9105 Main Street

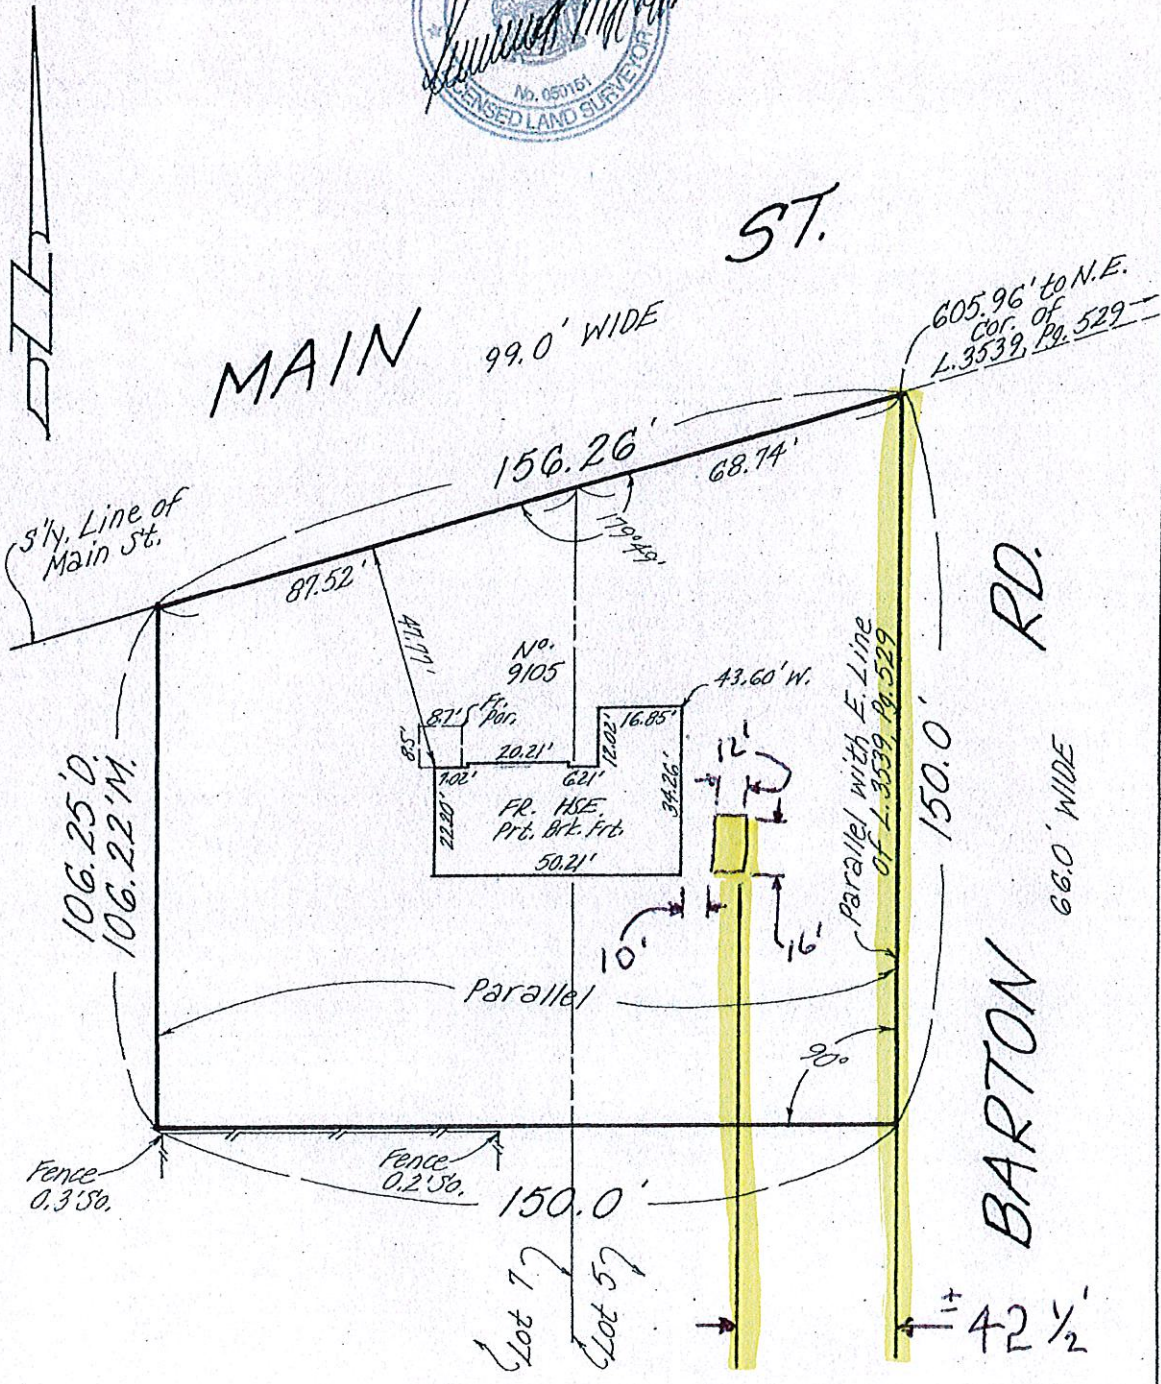
Existing detached accessory structure (shed) located within the front yard setback.

Detached accessory structures are only allowed in the side and rear yard setbacks.

A corner lot shall be considered to have two front yard setbacks from the public right-of-way to the closest point of the principal structure.

9905 Brauer Road

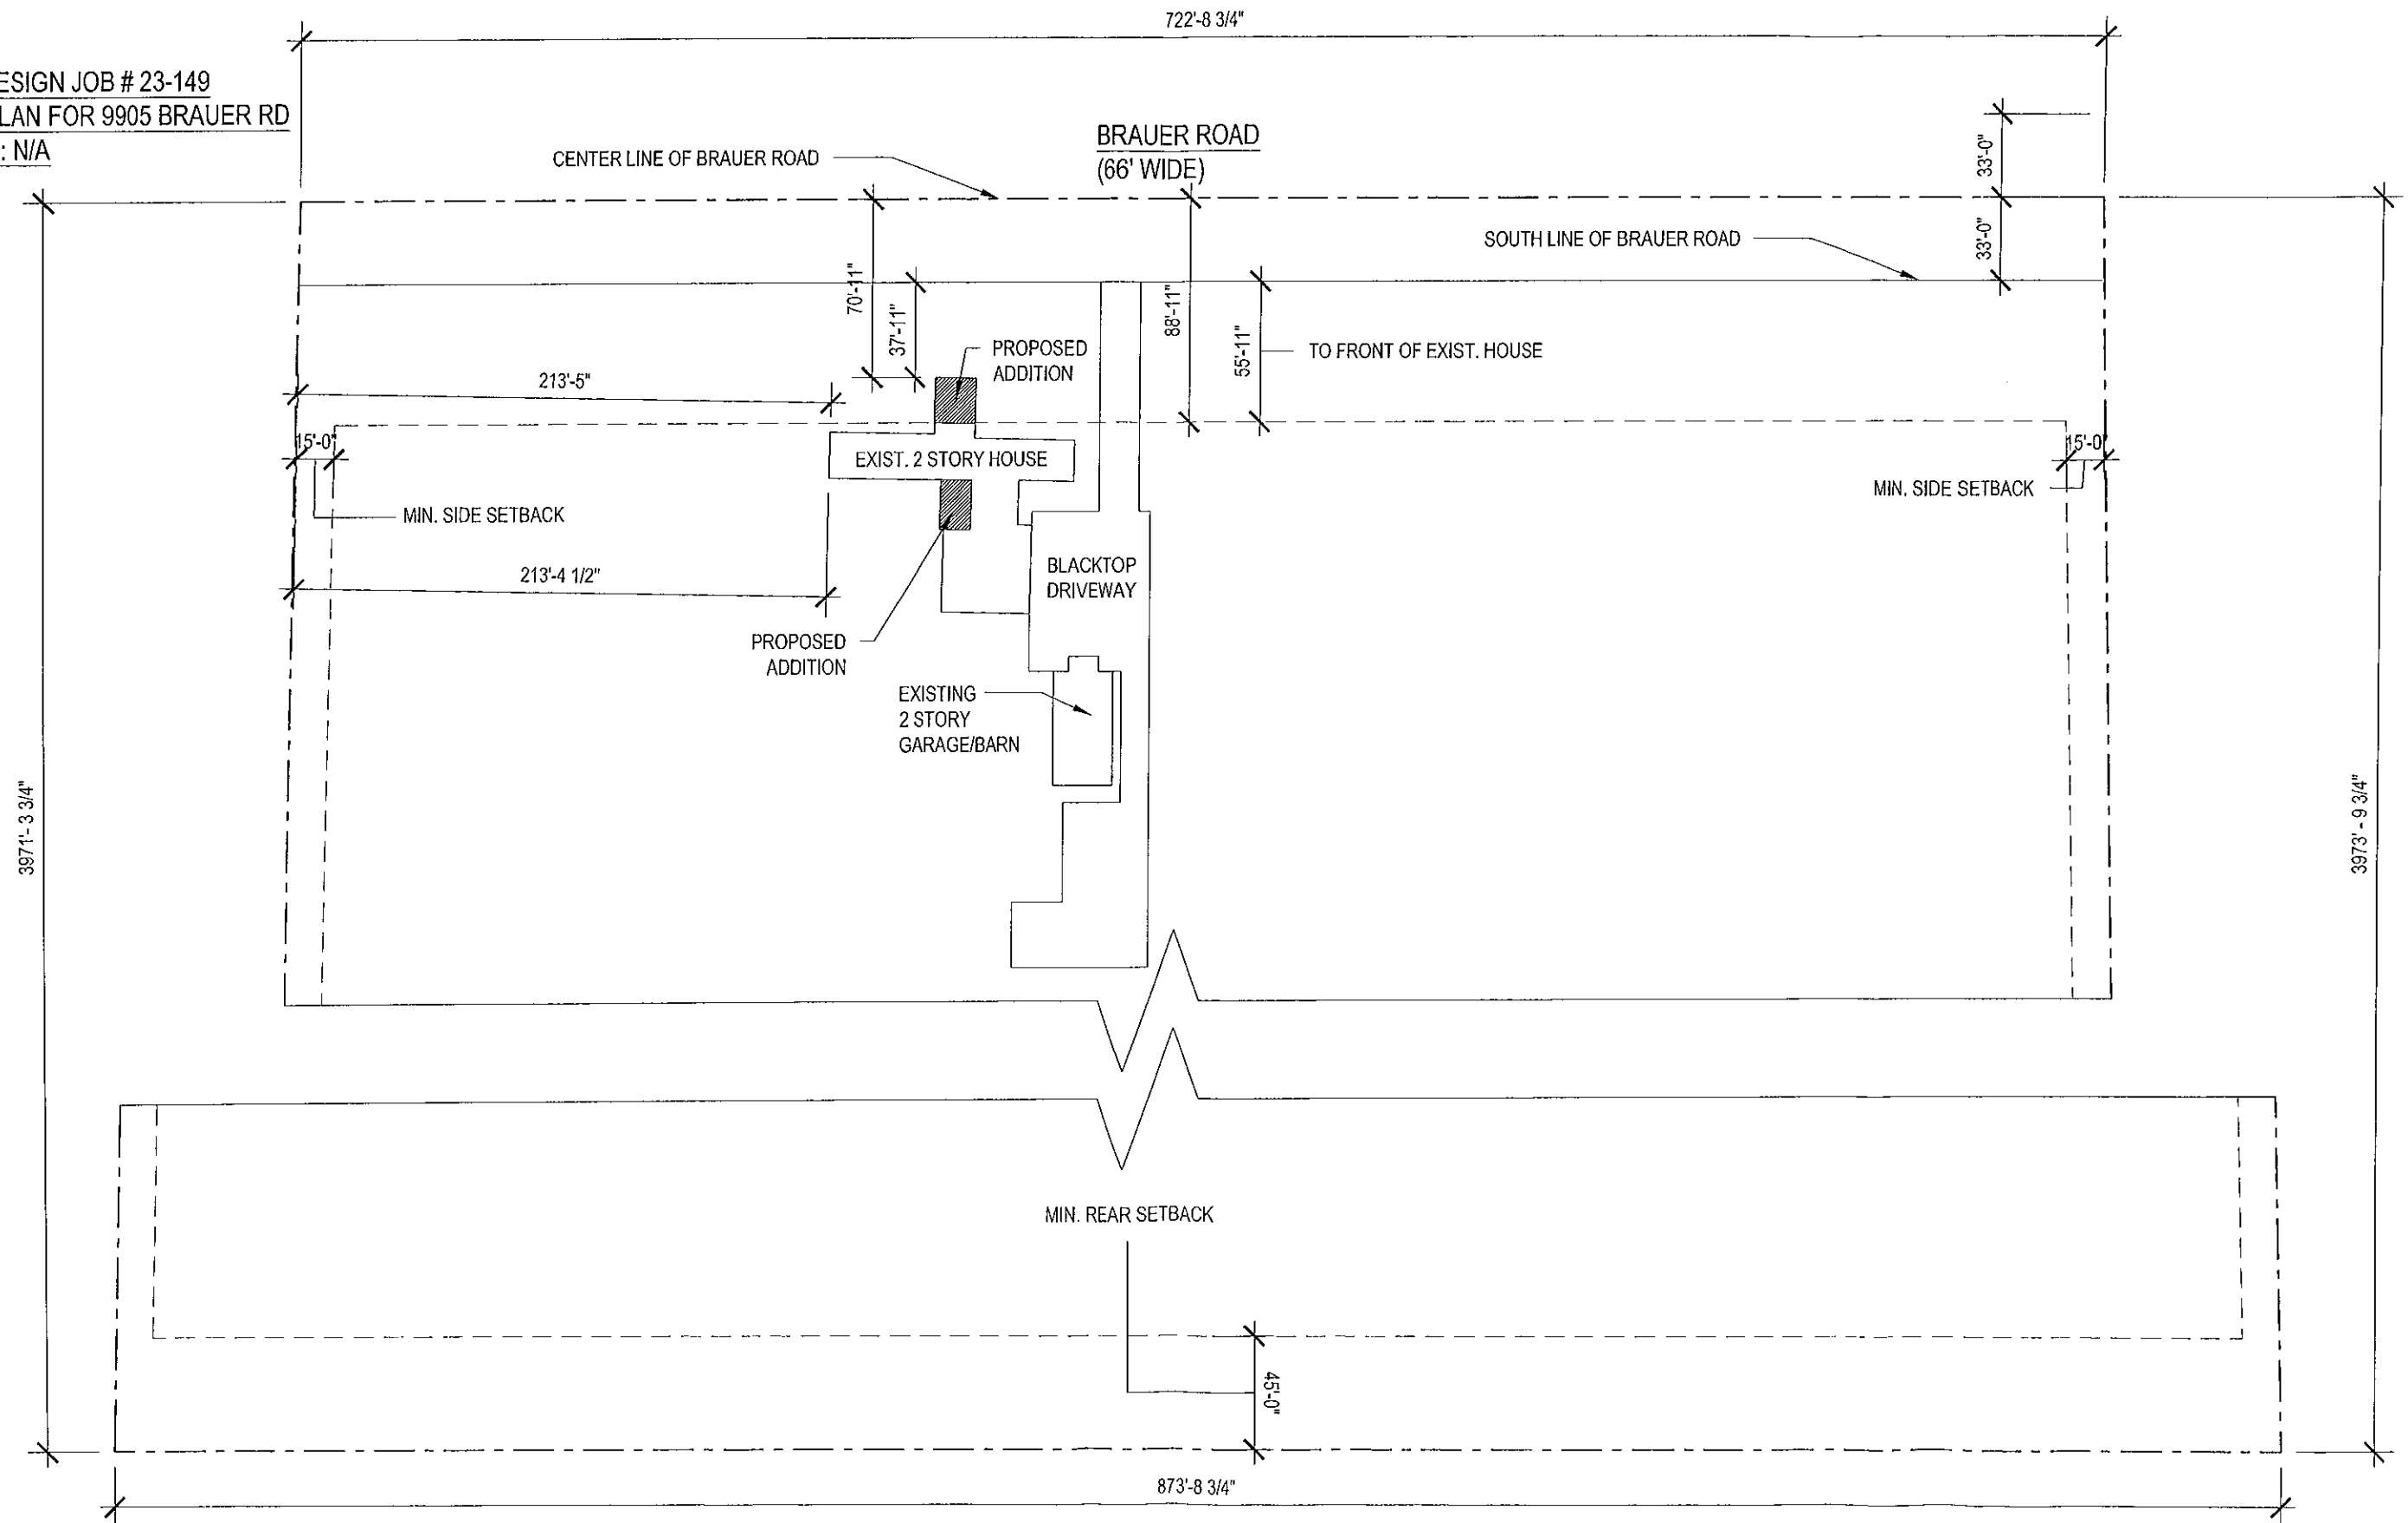
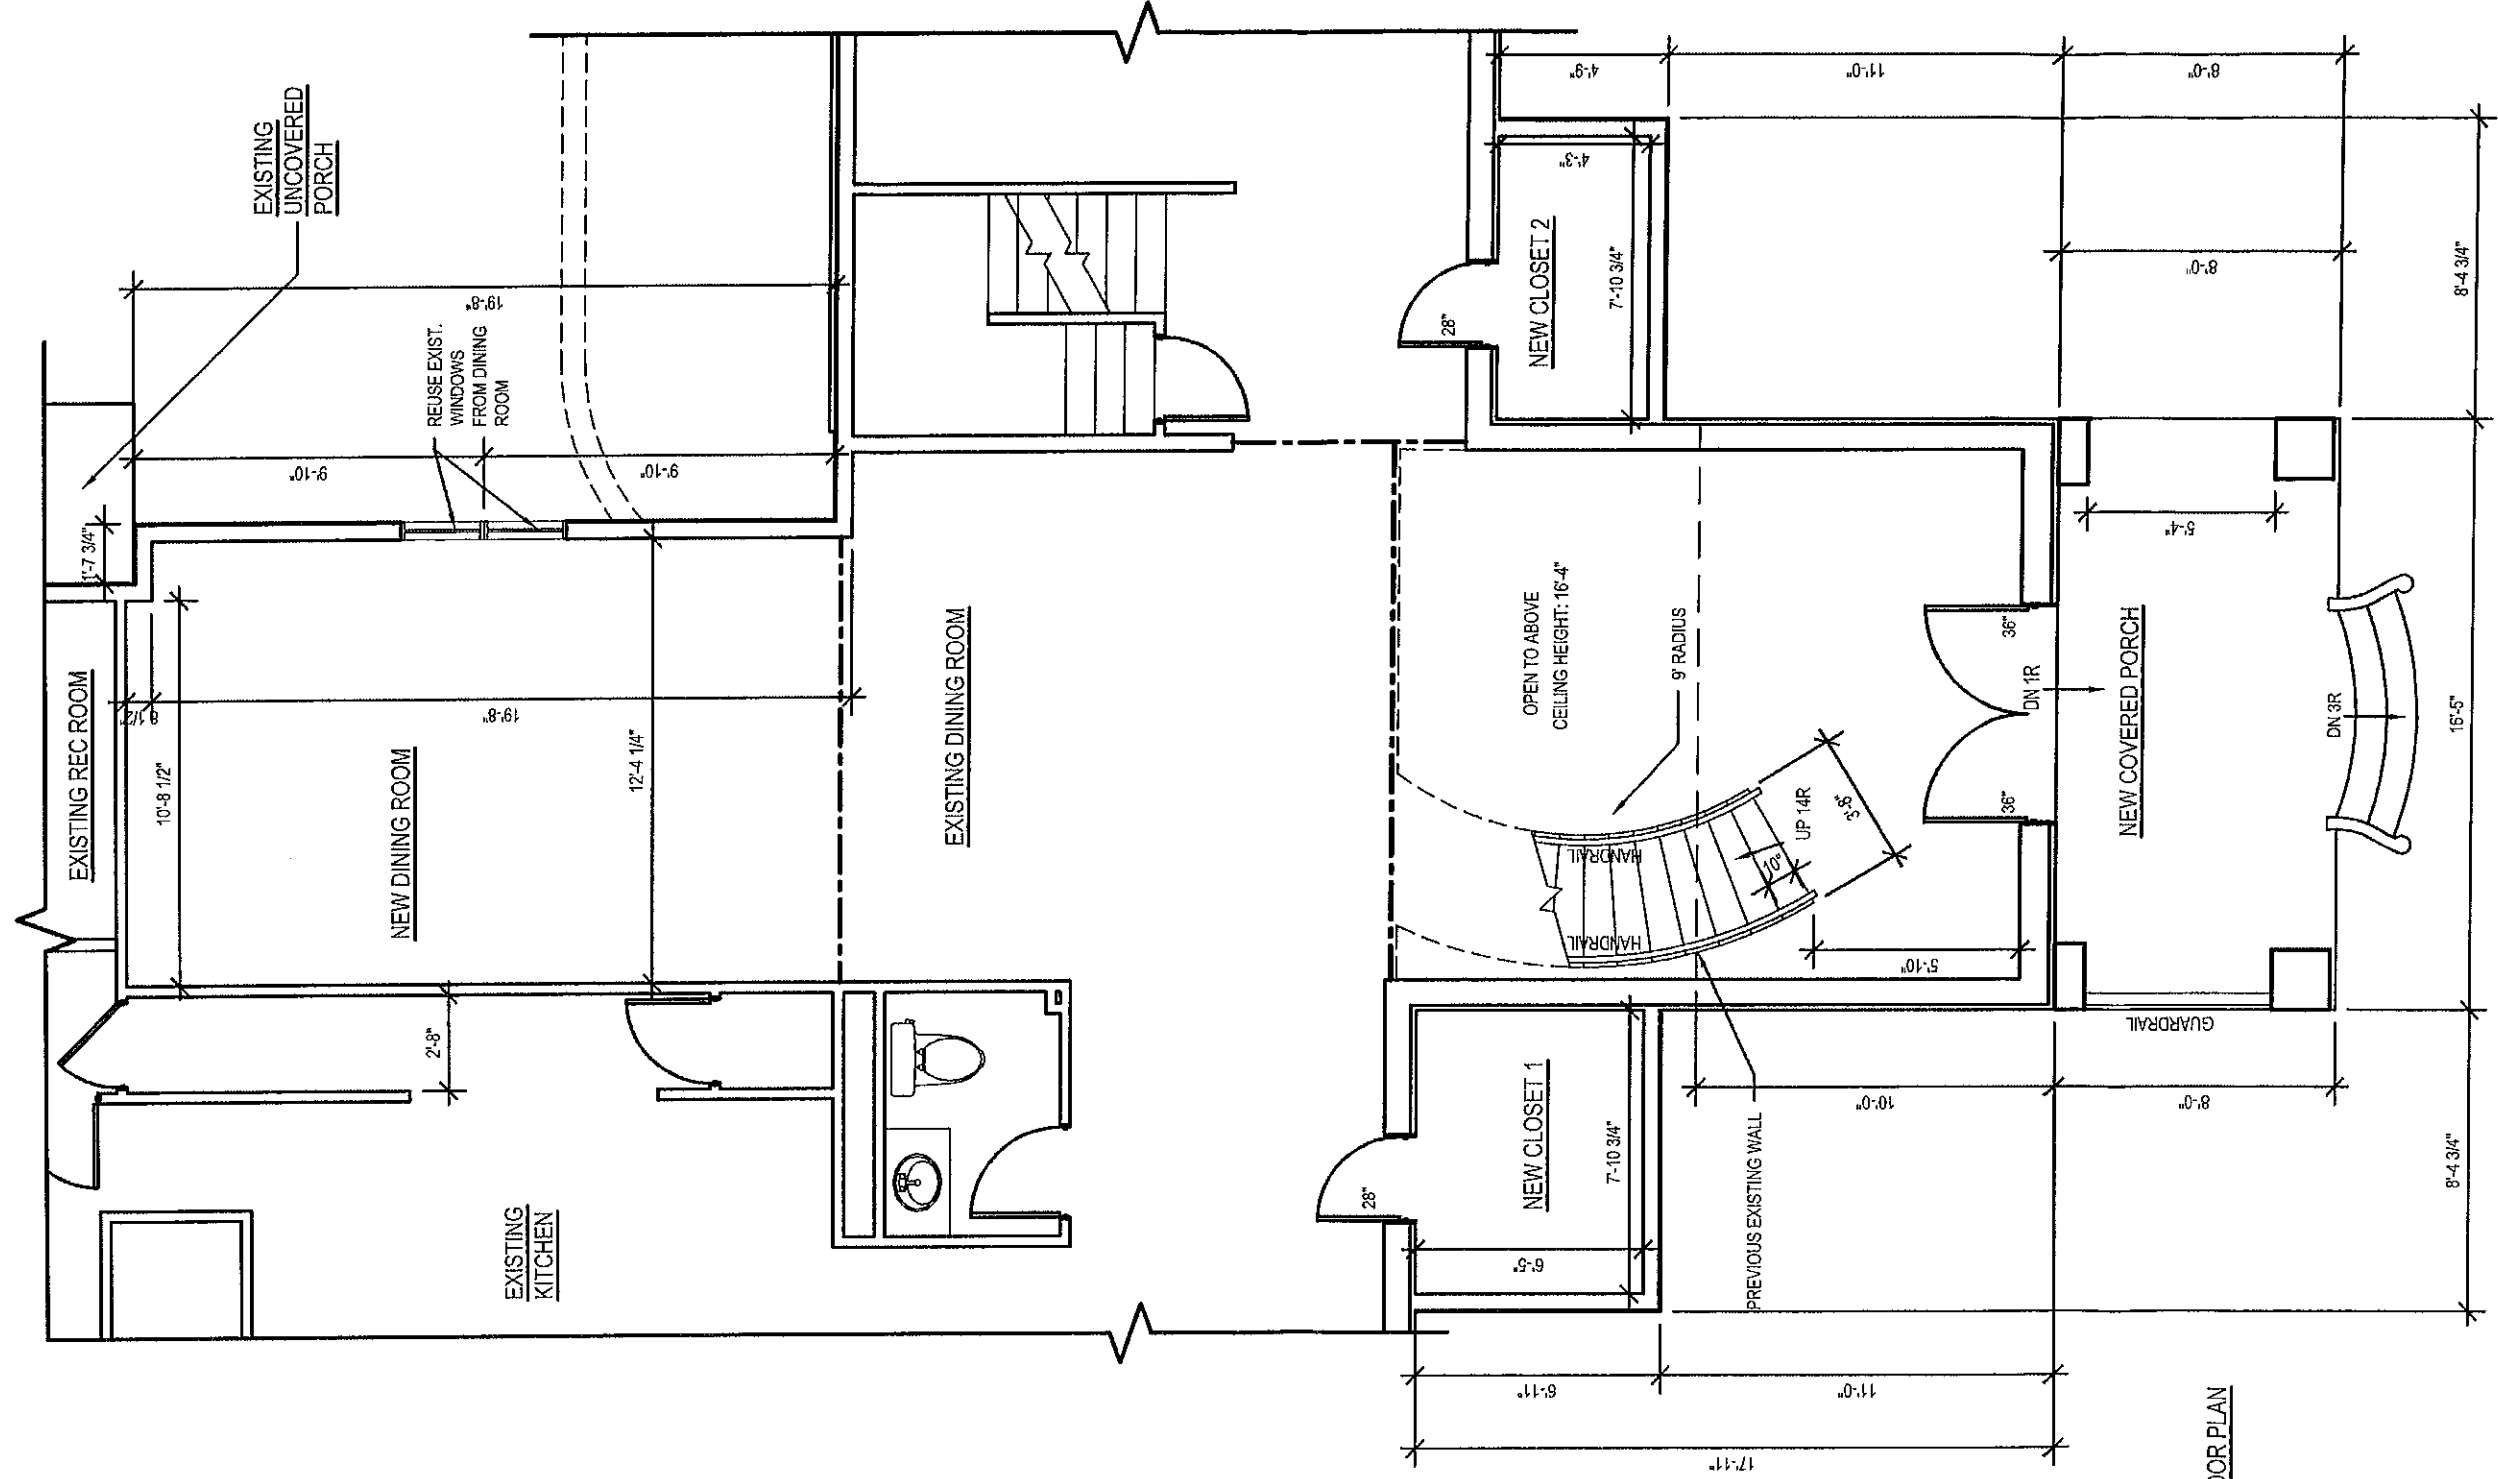
Proposed 37'11" front yard setback fronting Brauer Road.

Established front yard setback is 55'11".

An 18' variance is requested.
